ADDENDUM 3

DATE: November 18, 2016
PROJECT: MSB First Floor Infill LRC 3 & 4
RFP NO: 744-R1705
OWNER: The University of Texas Health Science Center at Houston
TO: Prospective Proposers

This Addendum forms part of and modifies Proposal Documents dated, October 19, 2016, with amendments and additions noted below.

Print Date / Time: 11/16/2016 8:34:59 PM
P/W Commission Number: 214-198R
Sheet Number: A-111

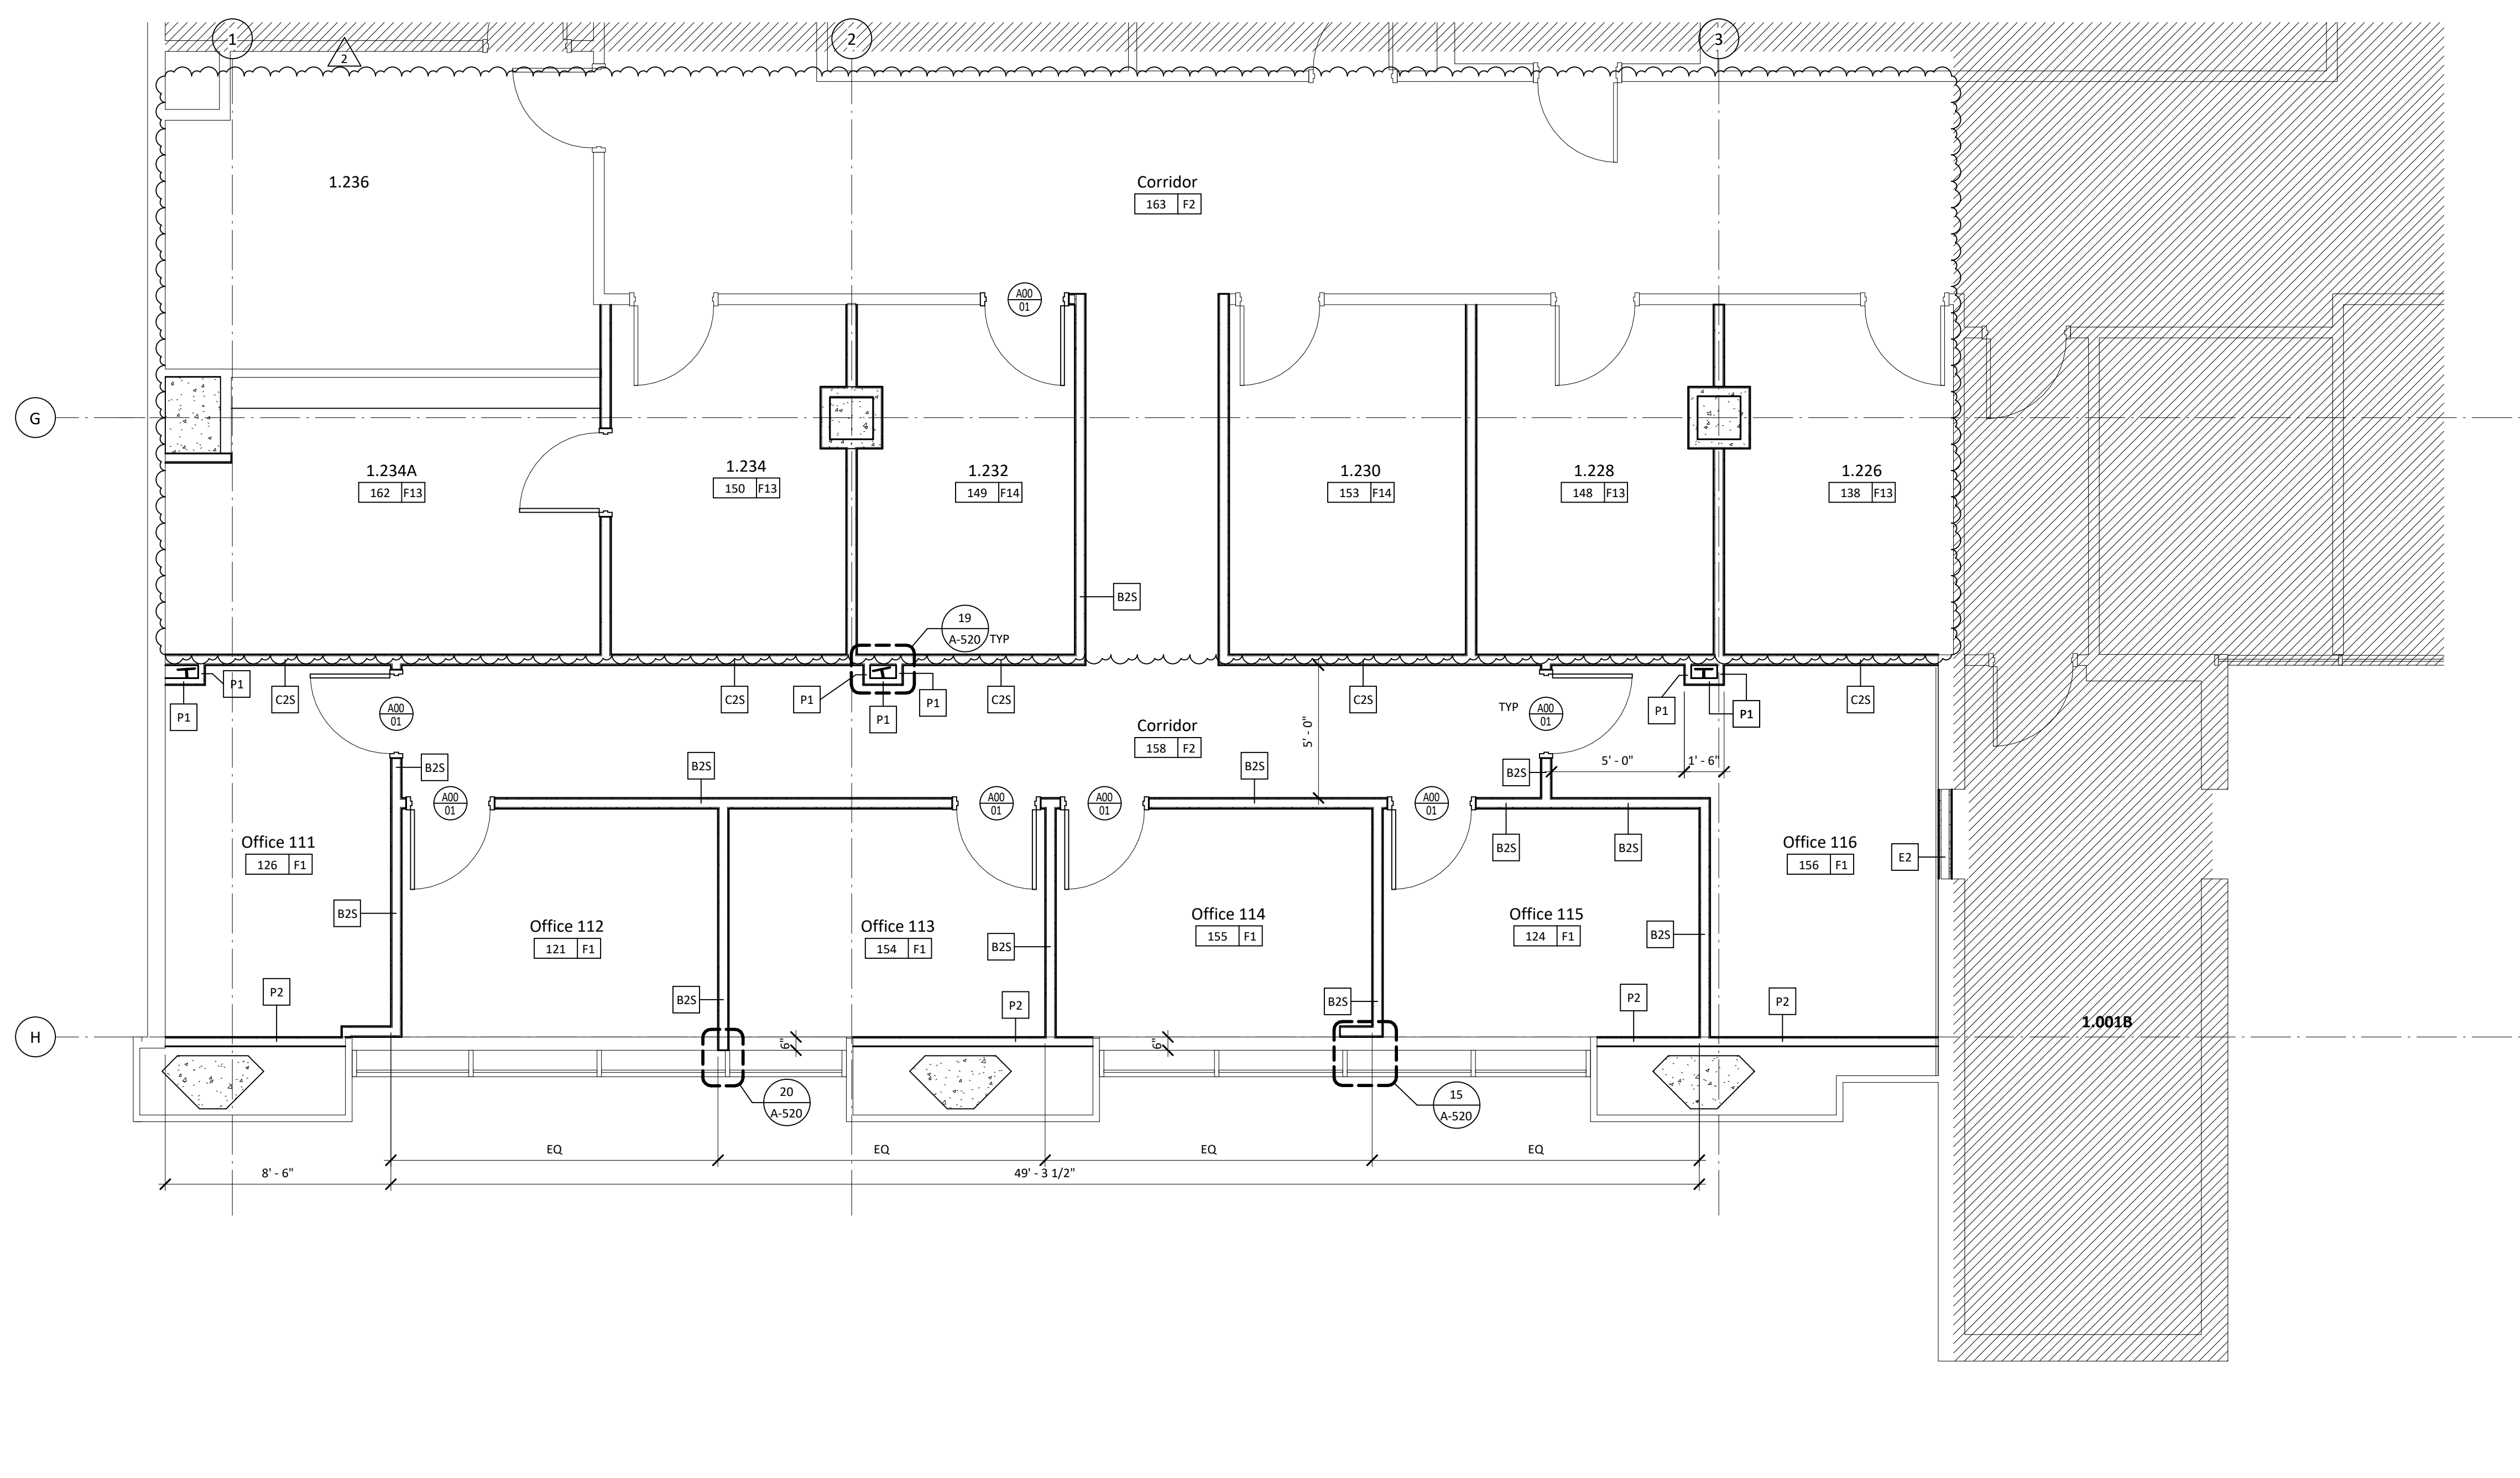
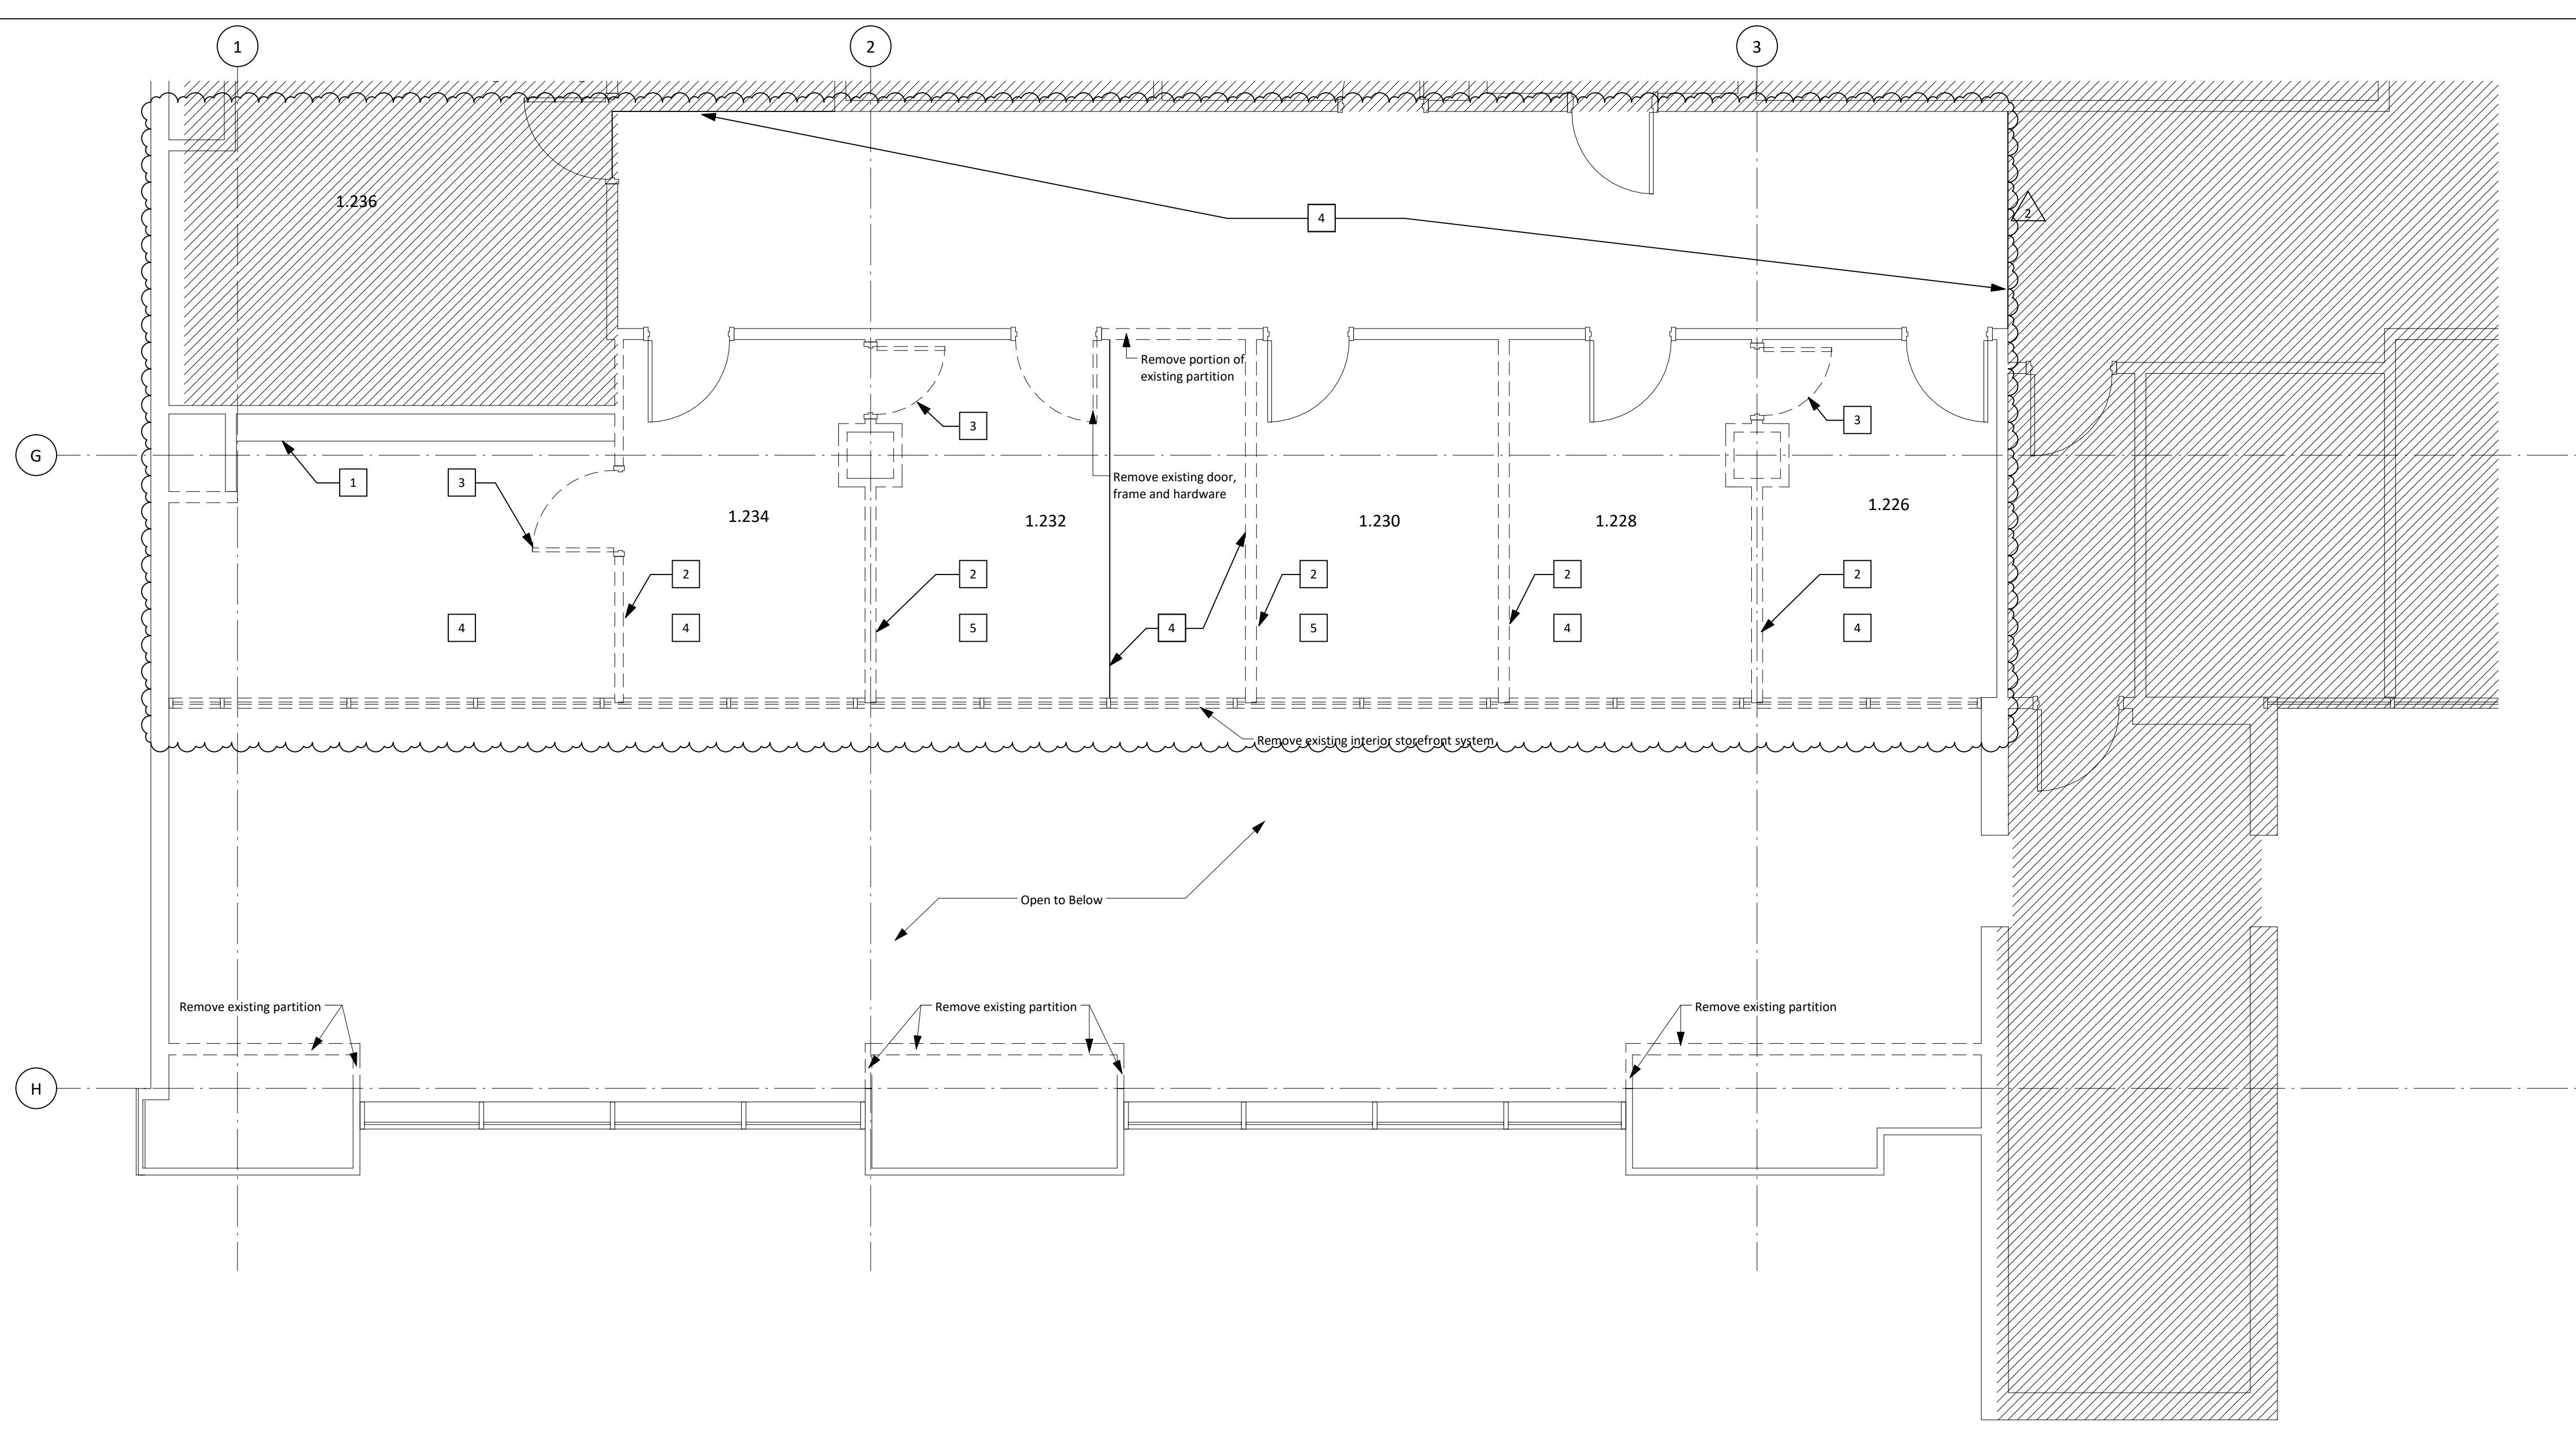
25. On drawing 2/A110 & 1/A111 - Please advise if fire rated shafts are to be built at the existing concrete columns along column line A (A110) and H (A-111). If so, please update partition type and provide details.
No fire rated shaft walls, fire safing to be installed between floors within existing shafts, detail to be provided in Addendum 3

Reflected Ceiling Plans - Ground Level

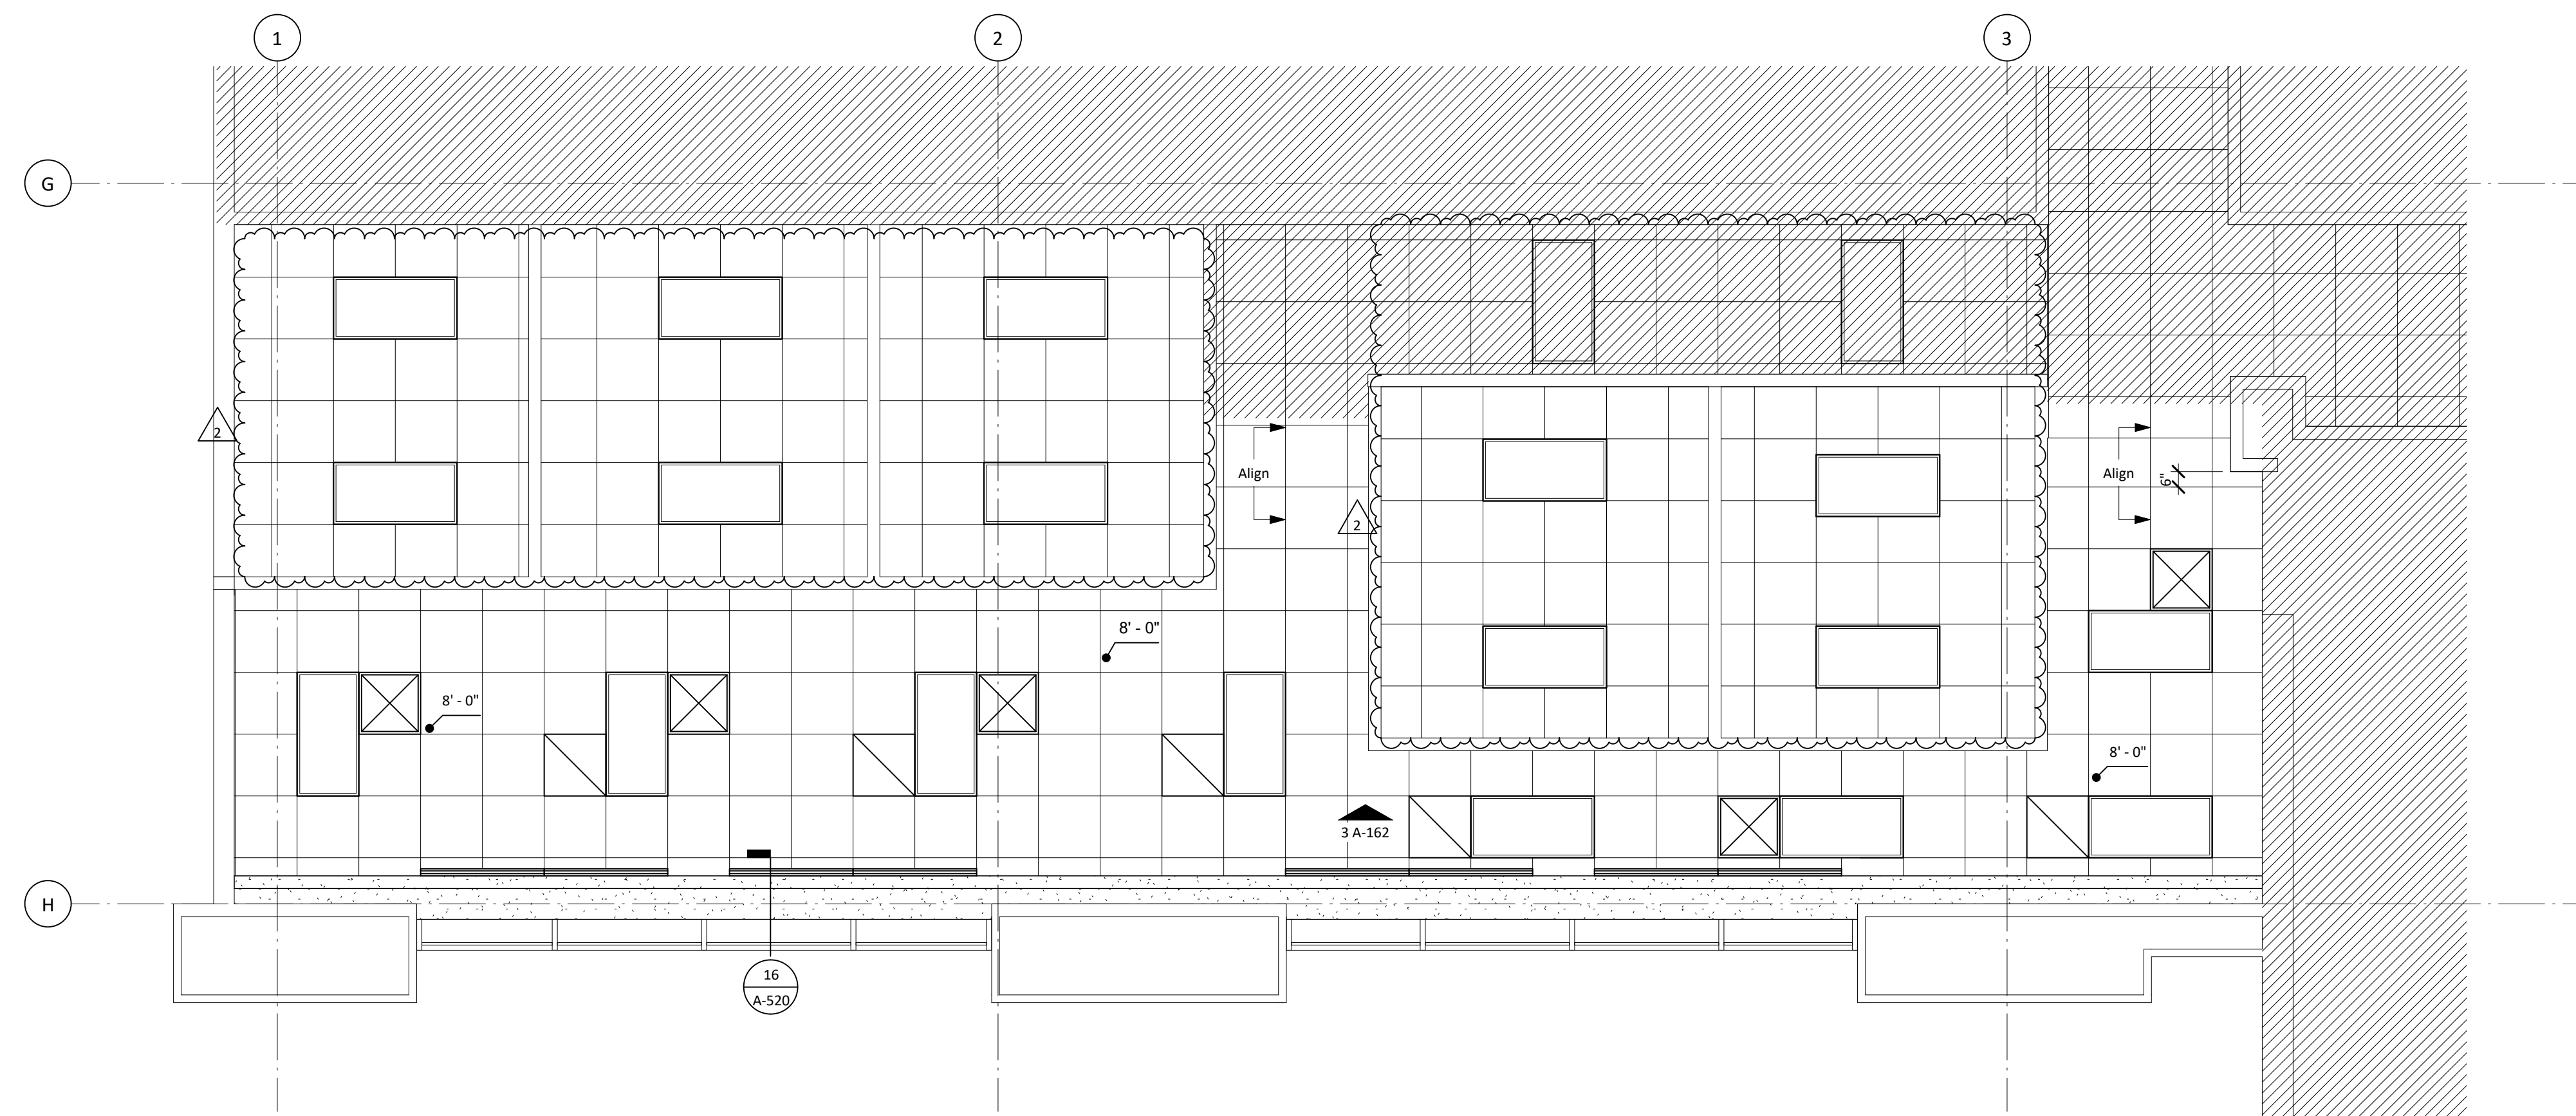
24. On drawing A-160 - Reflected Ceiling Plans Ground Floor detail 3, states to demo walls 4" above new ceiling. Offices will need to be completely demoed in order to operate crane during steel erection. Please advise.
Offices will be demolished and rebuilt
